Delegated Report

Householder Planning Application

Planning Application No: 20221134

Location: 88 Valley Drive Gravesend Kent DA12 5RX

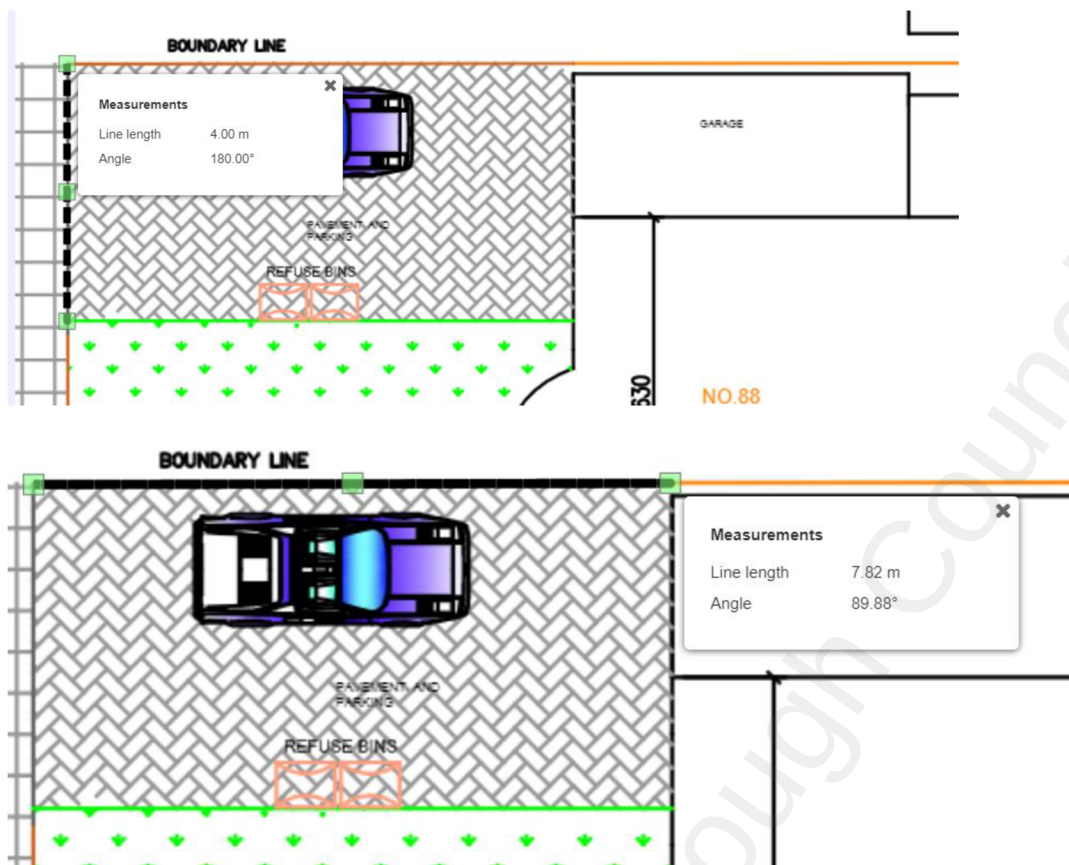
The proposal will change a three bedroom property into five bedroom one. So, to comply with SPG4 two secure cycle parking spaces should be provided.

The applicant also needs to demonstrate that two vehicles can be parked in the front garden. The current drive is of insufficient length to accommodate two standard size parking bays. However, there is sufficient space in the front garden to accommodate two vehicles side by side. Although in this instance the drive width should be 5.2 metres wide due to the enclosed boundary on one side. There may also be benefit in providing an additional width to ease pedestrian access to the property

Below is an extract from the application where I have measured the proposed width of the drive.

Therefore, unless I have measured incorrectly, I can only recommend a condition is attached to any permission to provide a plan showing the necessary car parking layout.

For clarity the existing and proposed elevations are shown below (Not to scale):

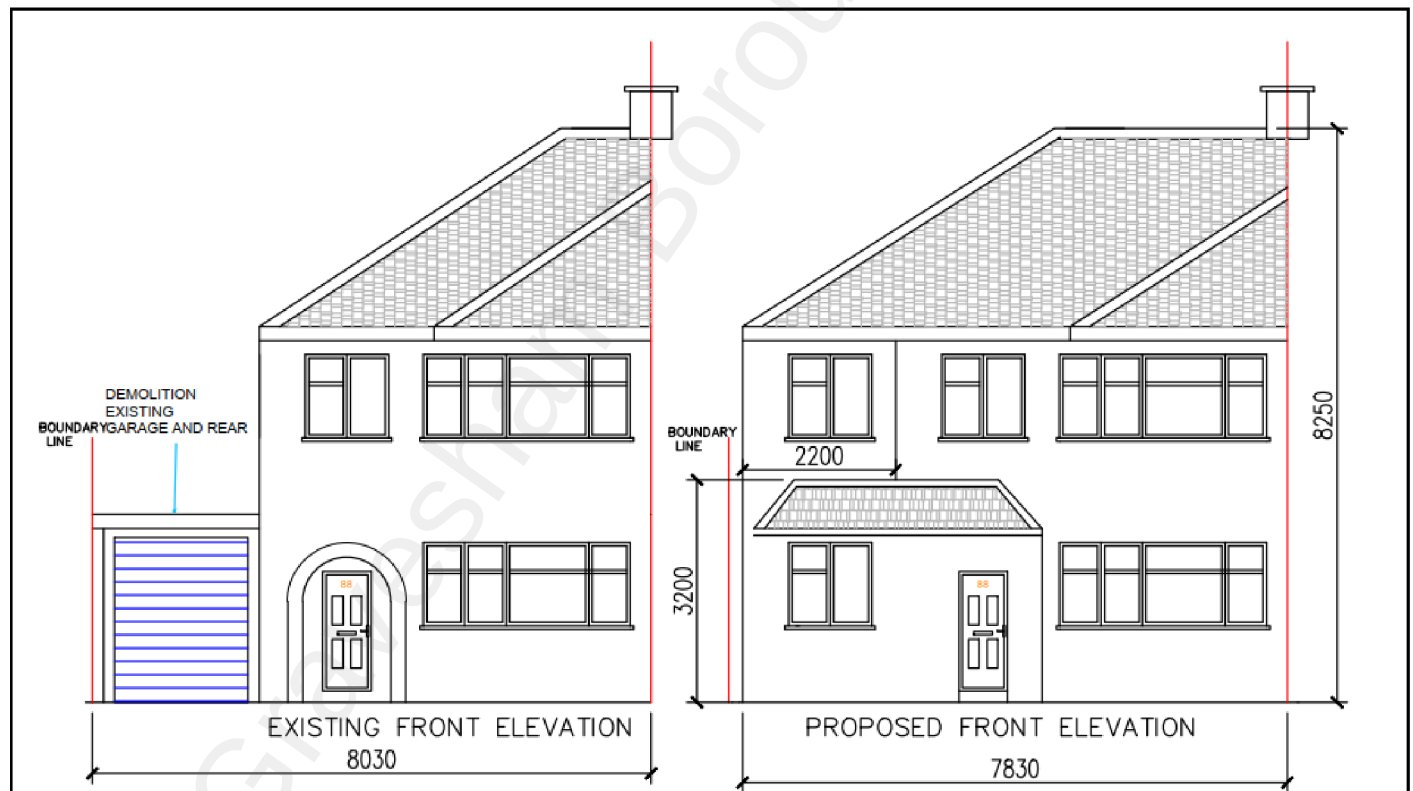
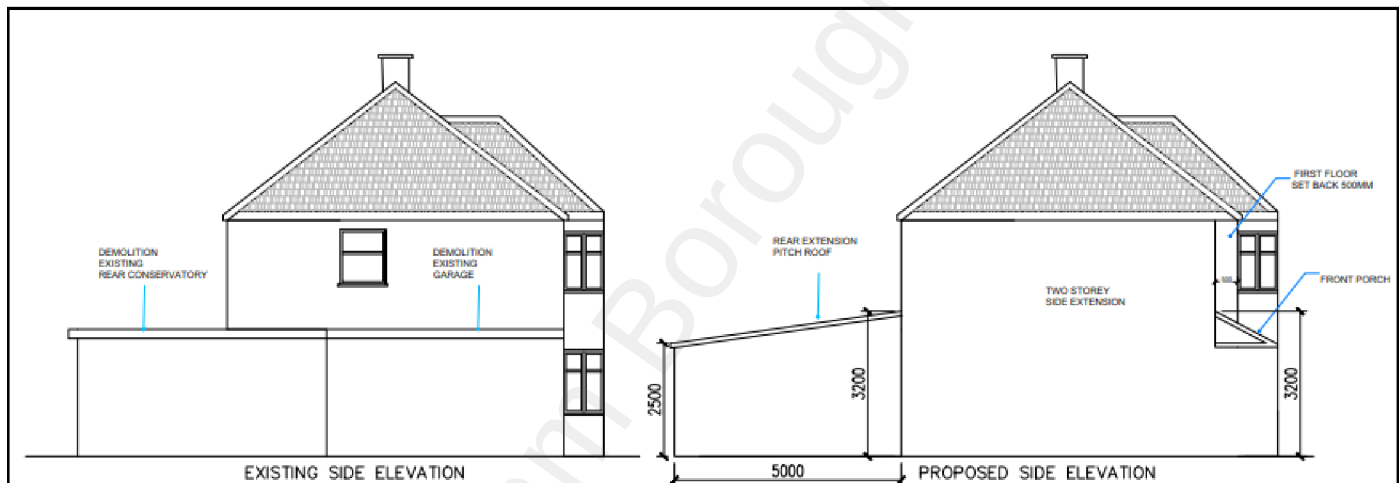
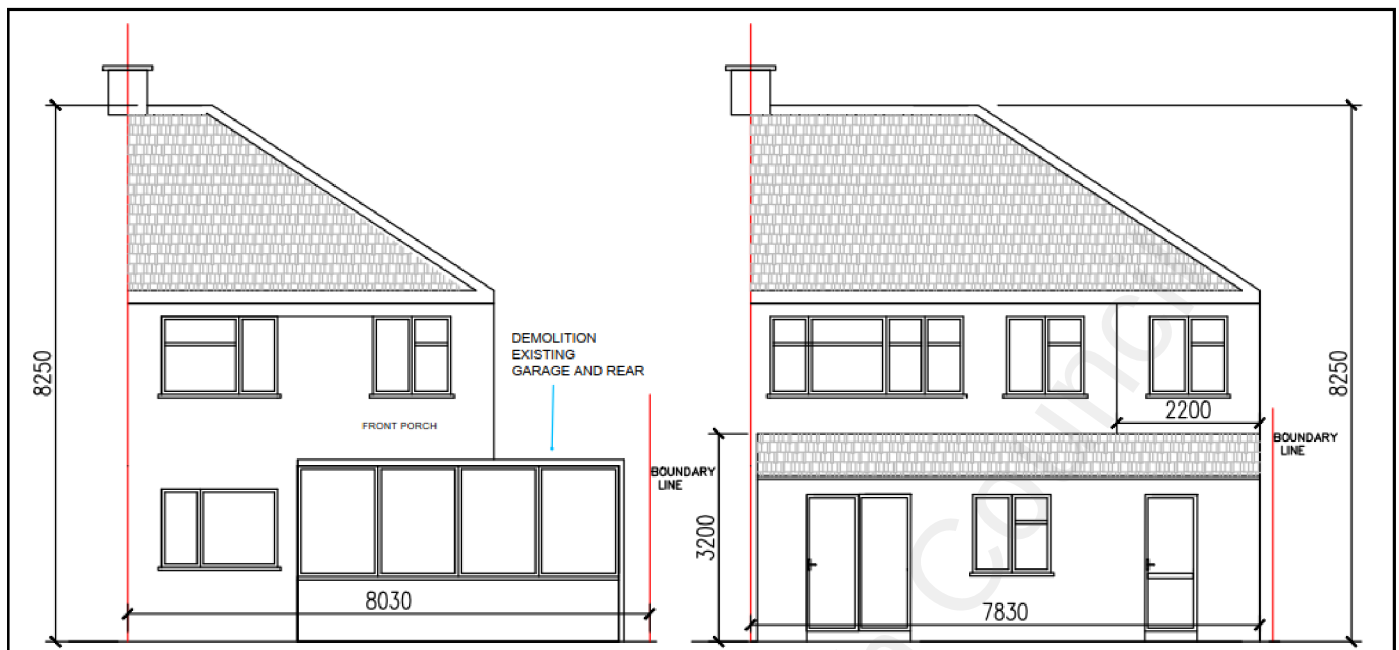
This particular two-storey side extension would fail to retain a 1 metre gap at the boundary, it would extend in line with the main dwellinghouse through a lack of subservience, with single storey elements set forward of this, it would also increase the width of the highest point (the ridge) by 2 metres, resulting in significant level of bulk and harsh and unsympathetic interruption to the visual spacing between dwellinghouses. It would also unbalance and interrupt the symmetry with the attached dwellinghouse. A token set back is proposed at first floor, but this is poorly designed with the roof matching the existing property resulting in an excessive overhang. For a set back to create the intended subservience, the roof also needs to be set down and back. The proposal is of very poor design.

The proposed single storey rear extension would not be significantly larger than the existing rear conservatory and it would use a pitched roof which would soften the appearance. It would be a subservient addition. Concerns are raised with regard to the accuracy of the plans. However, given that the recommendation is to refuse, it would not be conducive to a favourable outcome to require the correction of

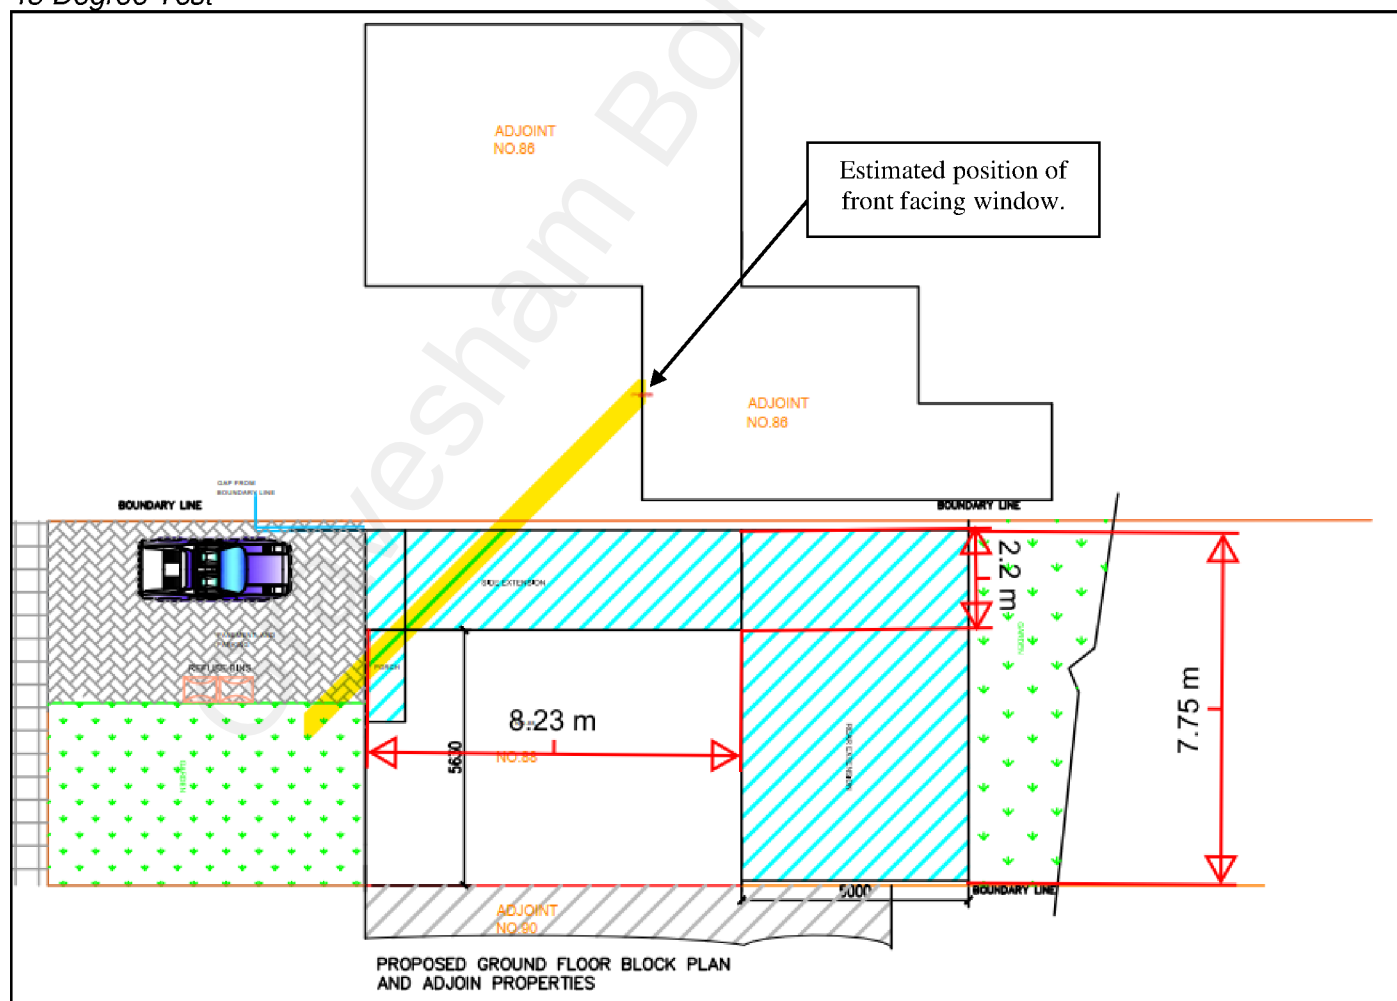
This neighbour is located to the south. The subject dwellinghouse meets the shared boundary with this neighbour at single storey level. There is a distance between the buildings of 0.7m-0.9m at single storey height. The two-storey elements of the existing dwellinghouse are 2.9m from these neighbours building. The proposed development would erect two storey elements at the shared boundary, 0.7m-0.9m from the neighbours dwellinghouse. This two-storey element would have a depth of 7.5m at this boundary, which would be overbearing on this neighbour in terms of bulk, given the close proximity, height and depth.

This neighbour's dwellinghouse is L Shaped and has ground and first floor windows to the side elevation and a first floor window facing forward which would potentially be overshadowed by the proposed development. Please see photograph below:

45 Degree Test

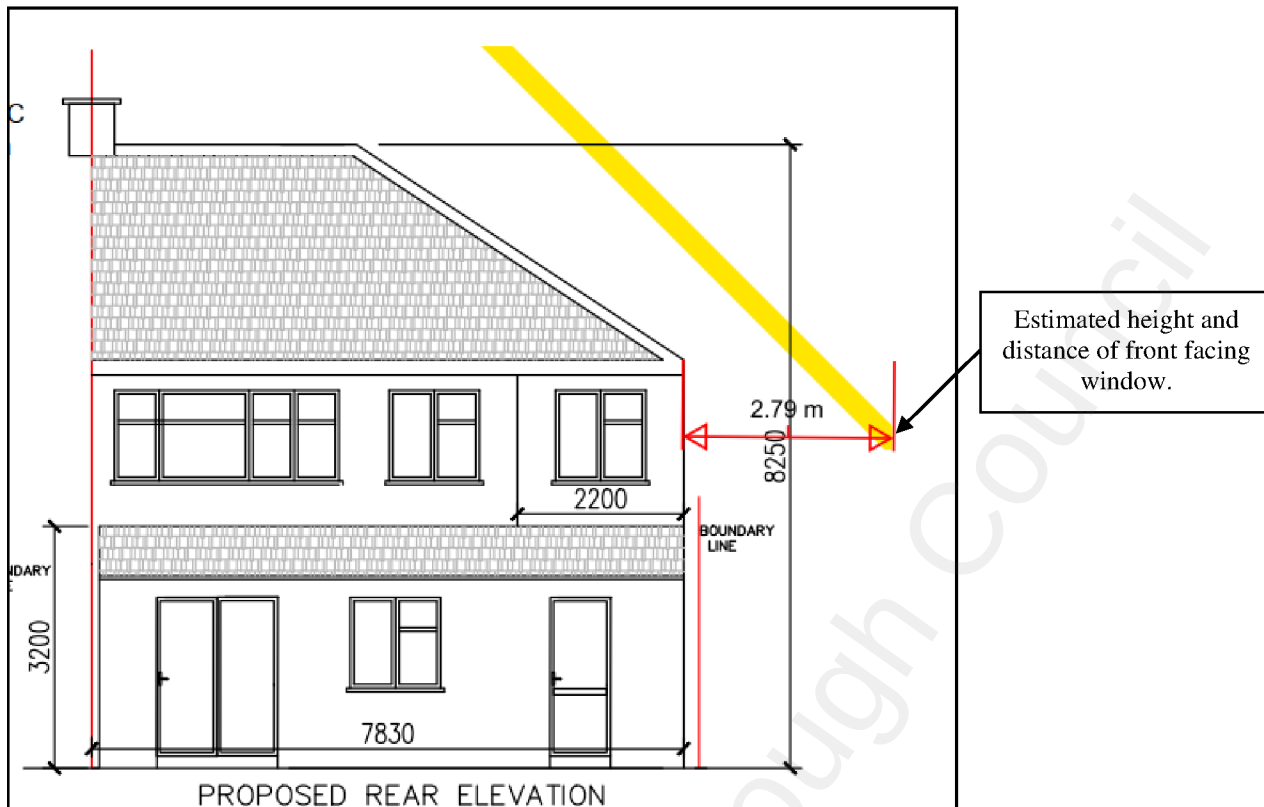
A 45-degree test should be undertaken to assess the impact on the front facing window. And a 25 degree test should be undertaken to assess the impact on the side facing windows.

As can be seen, given the distance at 45 degrees, the front facing window would likely not be overshadowed.

25 Degree Test

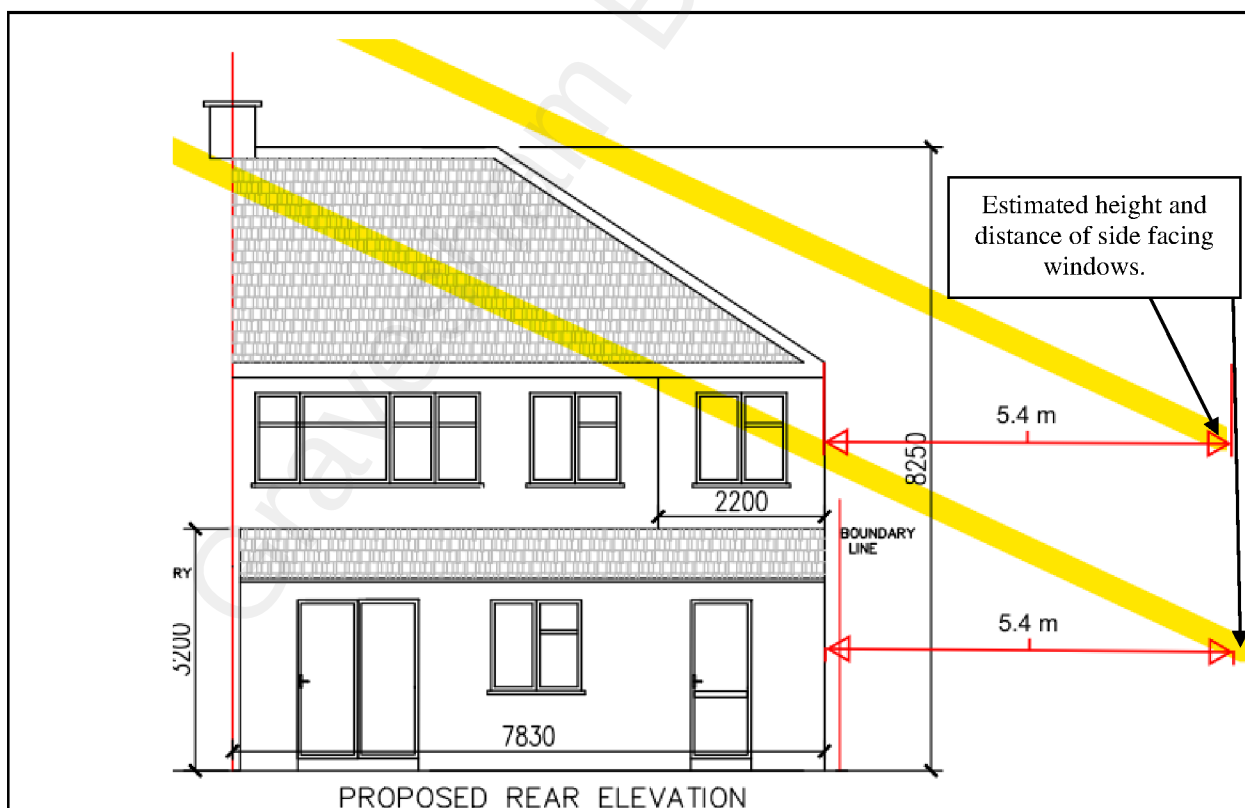
As can be seen above, the first floor side windows would likely not be overshadowed, but it is likely that the ground floor windows would be.

It should be noted that given the east to west, southerly route of the sun, any overshadowing of this window would likely be reserved to a small period in the early morning. Also, the most recent application for this neighbour's property (20040593), shows this window as serving a lounge/dining room, which is also served by the front facing windows. This room itself would therefore not suffer significant loss of light as a result of the proposed development.
